UNITED STATES PATENT AND TRADEMARK OFFICE

APPLICATION NO.	FILING DATE	FIRST NAMED INVENTOR	ATTORNEY DOCKET NO.	CONFIRMATION NO.
10/674,225	09/29/2003	Dennis A. Kramer	60,130-1898; 03MRA0456	2509
26096	7590	01/27/2006	EXAMINER	
CARLSON, GASKEY & OLDS, P.C. 400 WEST MAPLE ROAD SUITE 350 BIRMINGHAM, MI 48009			TORRES, MELANIE	
			ART UNIT	PAPER NUMBER
			3683

Office Action Summary	Application No. 10/674,225	Applicant(s) KRAMER, DENNIS A.	
	Examiner Melanie Torres	Art Unit 3683

DETAILED ACTION

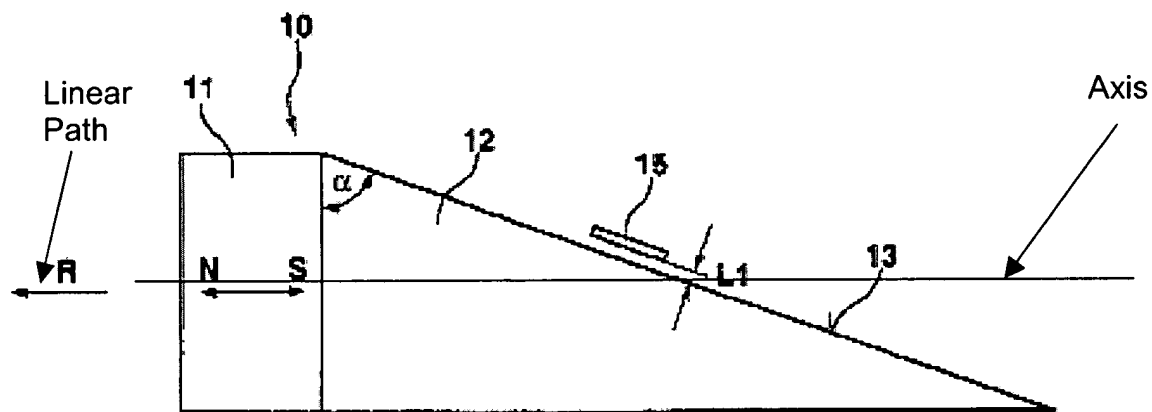
Re claims 13-17, Reichl et al. discloses a distance sensor comprising: a magnet (11) having at least a north pole and a south pole, with an axis defined extending through said north and said south poles; and a Hall effect sensor (15) said Hall effect sensor and said magnet being mounted for movement relative to each other along a linear path (R) said linear path being non-parallel to said axis. See below.
